TOYOTA CUSTOMER SERVICES

Volume: XV
Number: TC08-018
Date: 12/10/08
 Action
 Retain
 Information

SUBJECT: **Non-Compliance Recall (Special Service Campaign) – 80D**
2008 Model Year Highlander and Highlander HV equipped with Third Row Seat

**SPECIAL SERVICE CAMPAIGN 80D (NON-COMPLIANCE RECALL)
THIRD ROW SEAT BUCKLE BRACKET REPLACEMENT**

C. INSTALL THE BUCKLE BRACKET

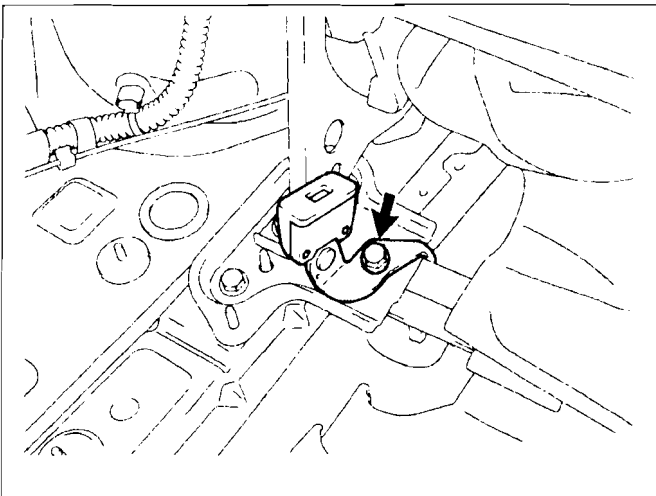
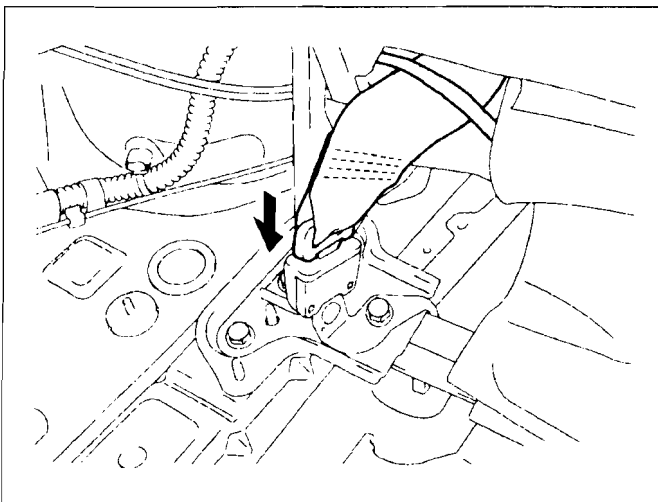
- The new bracket shortens the belt path by eliminating the webbing.
- The alignment of the LH bracket may be slightly off-center. Carefully start the bolt by hand with the bracket in the correct orientation, then torque to specification.

- a) Install the NEW buckle bracket.
- b) Install and tighten the bolt to specification.
- c) Repeat steps for the opposite side.

Torque Specification:
42 N·m (428 kgf·cm, 31 ft·lbf)
